Memorandum

To: Planning Commission
From: Niall Connolly, Principal Planner
Date: October 10th, 2025
Re: Design Development Review, New Residence at 54 Hummingbird Lane

Figure 1. Aerial view showing the options for the 20 ft wide fire access. Green Lines signify property lines.

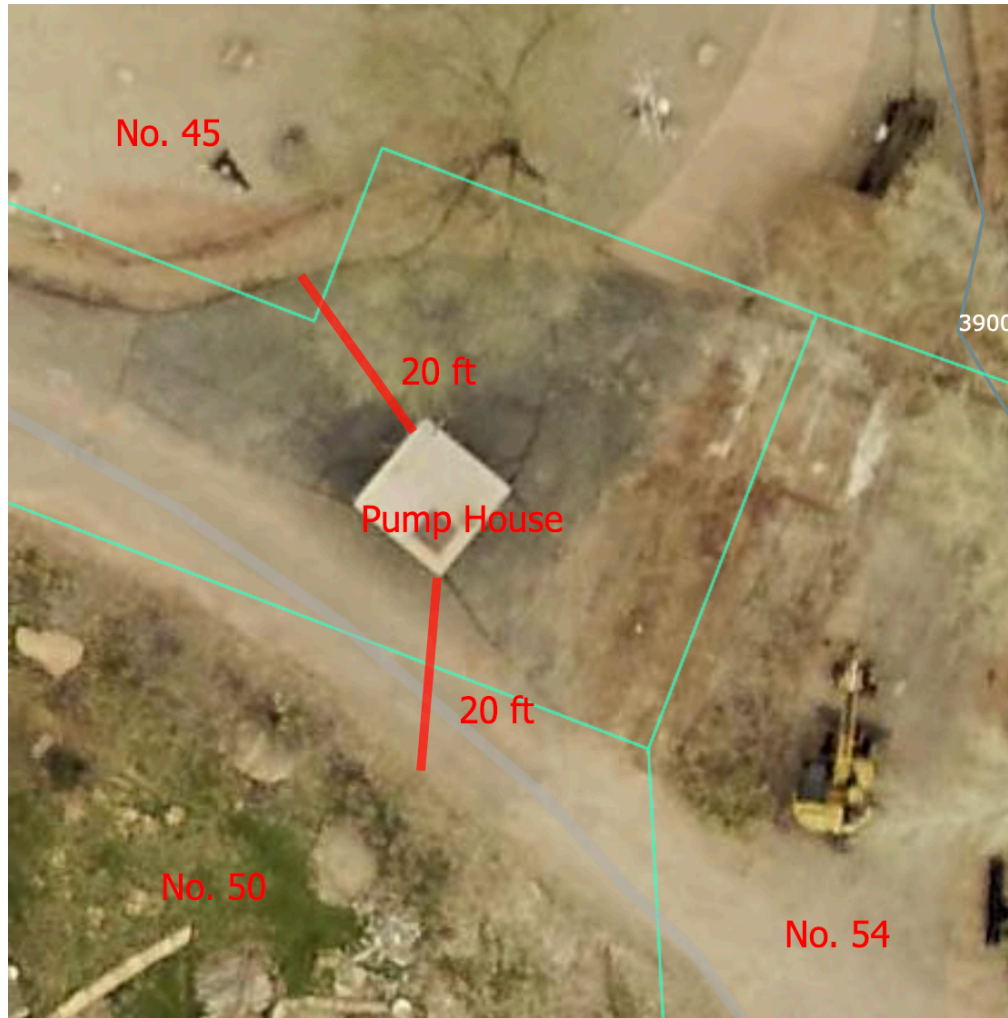
The Fire District requires a 20 ft wide all-weather access to the property. The previous application showed this access cutting across a corner of no. 50 Hummingbird Lane's front yard. The Town pump house building sits at the end of Hummingbird Lane and obstructs access. Therefore, to achieve a 20 ft wide access to the property, the access included this corner of no. 50's yard.

This new application shows the 20ft wide access on the other (north) side of the pump house. This access arrangement crosses a small piece of land which is the property of no. 45. Both routes (north of the pump house and south of the pump house) have an existing 20ft width of all weather surface. However, in either case, the access depends on some land outside the applicant's ownership. Our understanding is that the applicant has not, to date, secured an easement from either of the property owners (no. 45 or no. 50). Town Staff's understanding is that the Fire District will require this for their approval.

The Town Code does not require Fire District approval for Design Development Review applications. Instead, the Town requires confirmation from the Fire District at the Building Permit stage that the plans comply with their standards. The Town encourages applicants to engage in pre application consultation with the Fire District to ensure their plans comply with their standards.

Figure 2. Aerial view showing the distance between the proposed house and pool and the river

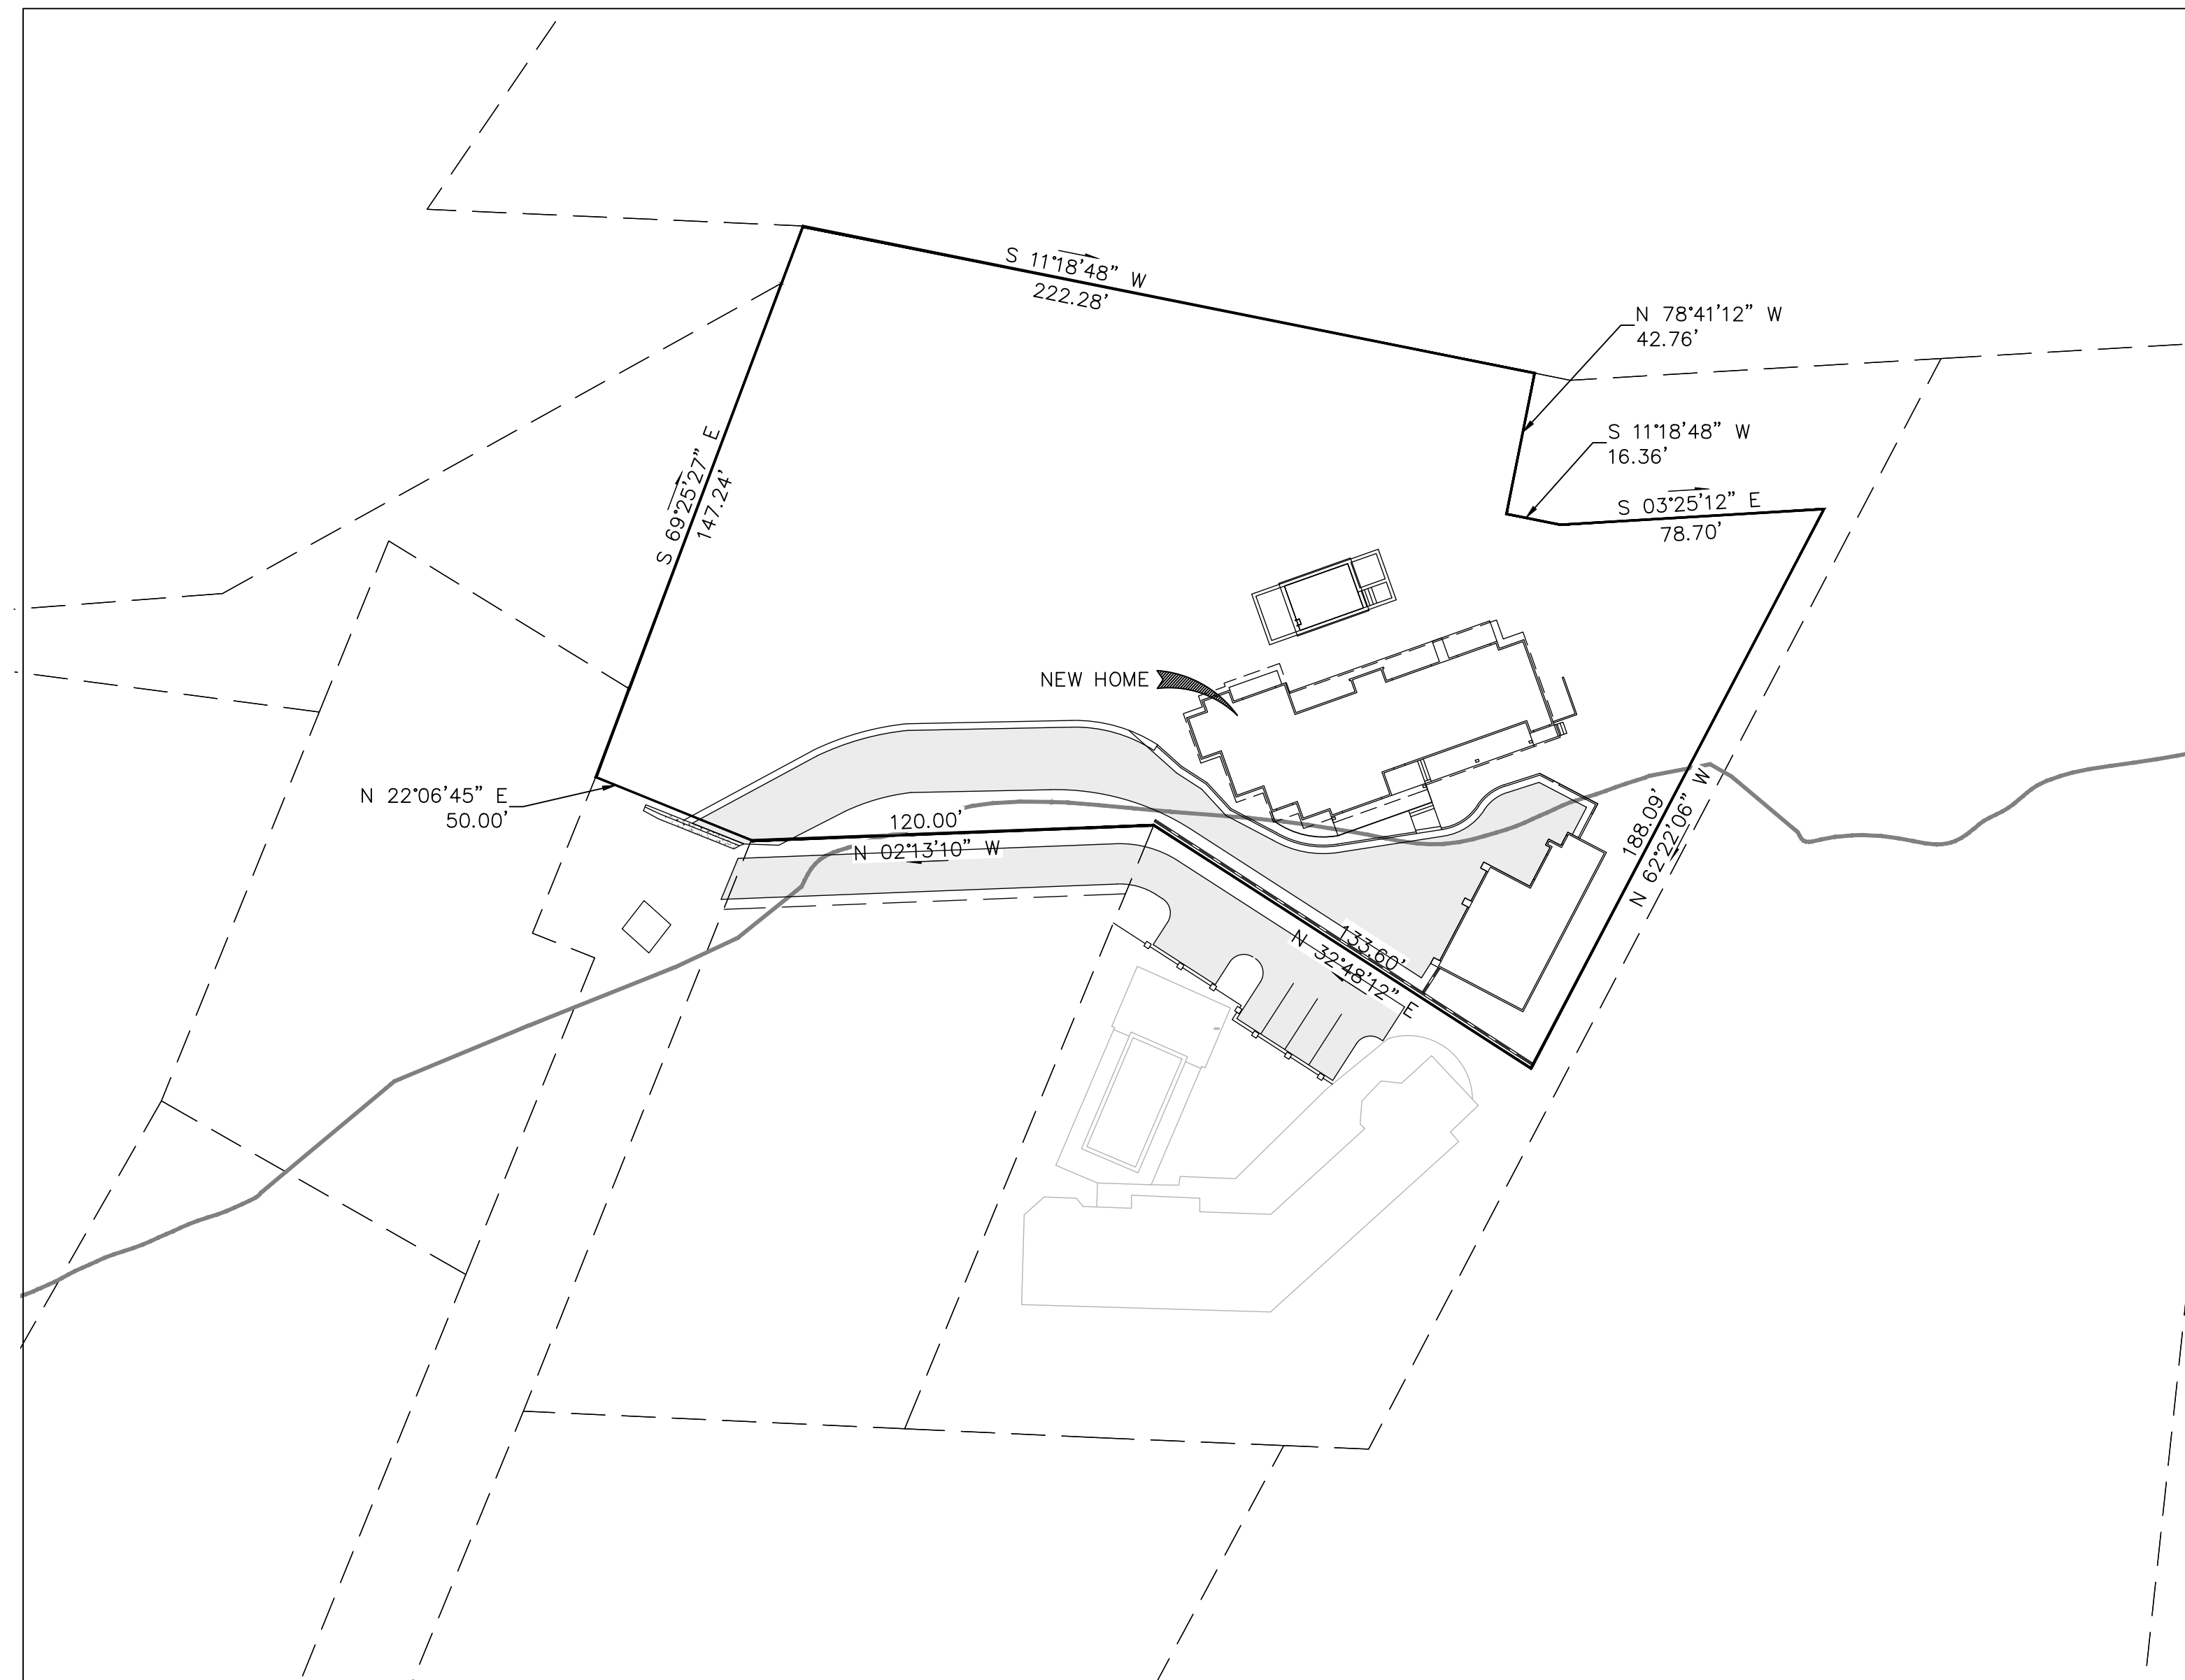
committed to work with the Town to establish an easement for this trail *“if and when similar trail easements or public rights of way are obtained on adjacent properties that would allow the development of a continuous trail through and across the adjacent properties”*. This easement would be 10 ft in width, along with temporary 5 ft construction easements on either side. While delivery of this trail remains a goal of the Town, no easements have been secured, to date, on neighboring properties. The proposed layout does not prejudice the delivery of this trail at some point in the future, as there is sufficient space between the proposed house and pool and the river (see figure 2 below).
